Interactive comment on “Rain concentration and sheltering effect of solar panels on cultivated plots” by Yassin Elamri et al.

Received and published: 17 October 2017

Fig. 1. rain depths (mm) collected in the two lines of collectors ("Ligne 1, Ligne 2)

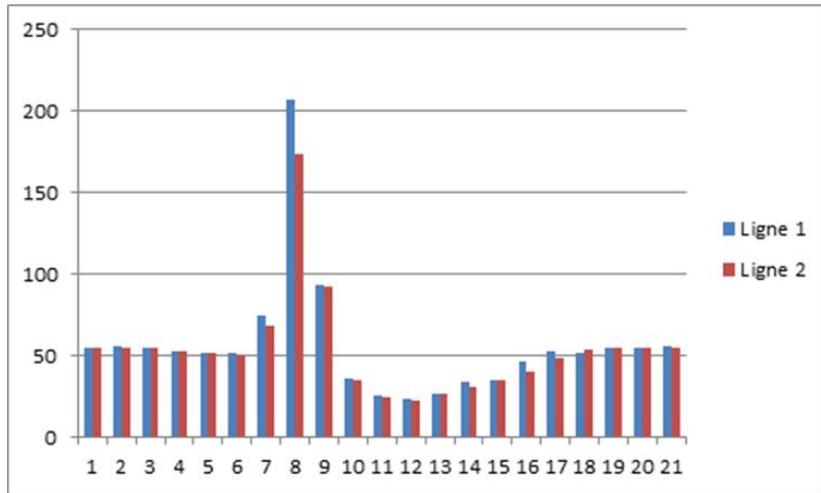
R1: Line 129 and Fig. 1: For a better evaluation of distribution uniformity under the solar panels it would be better to use a grid of collectors or replicate the series of 21 collectors more times along the PV row. The results here reported should be consid-

ered partial. See also the comment below on the use of coefficient C_v .

We used a second series of rain collectors indeed for event #12. The results we very close to each others in the two series of collectors (see below).

See as attached document: Figure 1 : rain depths (mm) collected in the two lines of collectors (“Ligne 1, Ligne 2) See as attached document: Figure 2 : correlation between rain depths collected in the two lines

Due to the time necessary to collect all the samples, we could not increase the sampling, so we agree to indicate them as partial. The results could be used nonetheless to check the validity of the model AVrain, where no calibration was necessary to fit on the data (for any of the 12 rain events described in the manuscript).

Fig. 3. Correlation between DU and Cv

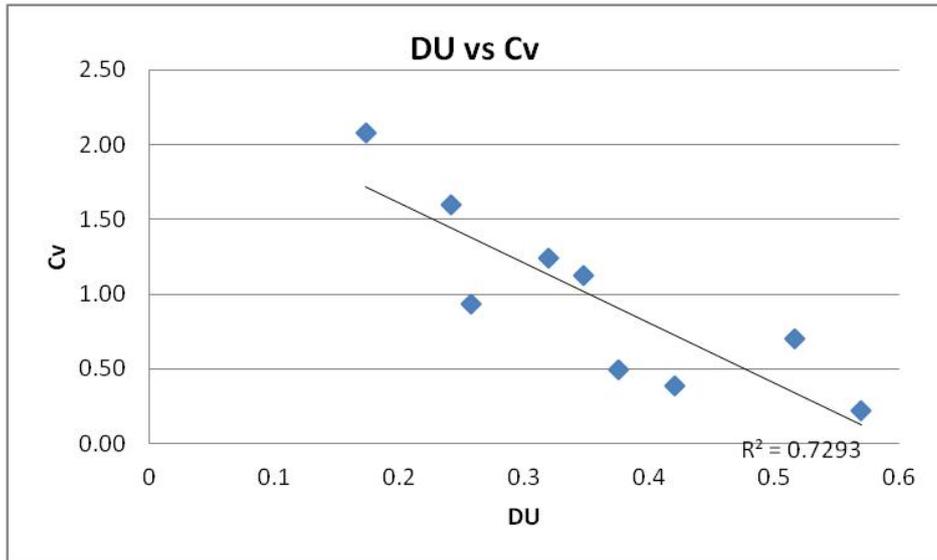
R1: Table 1: As regards the Cv see also the comment above. The values here reported are not supported by a proper data analysis.

We agree that these values are not reported in a unique document. The article of Burt et al. (1997) indicates the value of 80% for fair uniformity. It also indicates the linear behavior between DU and CV (equations 14, 15): $DU \approx 1-K Cv$ with $K \approx 1$. Therefore we selected the threshold of $Cv= 0.2$ for fair distribution. This is supported by other studies using Christiansen coefficient: "Catch can measurements are used to determine the uniformity of a sprinkler irrigation system. Christiansen (1942) developed a numerical index representing the system uniformity of overlapping sprinklers. This uniformity coefficient (UC) is a percentage on a scale of 0 to 100 (absolute uniformity). A uniformity coefficient of 80 is considered by many to be the minimum acceptable performance. Higher uniformity coefficients are usually needed with intensively maintained ornamentals. Catch can measurements are also used to illustrate water distribution or
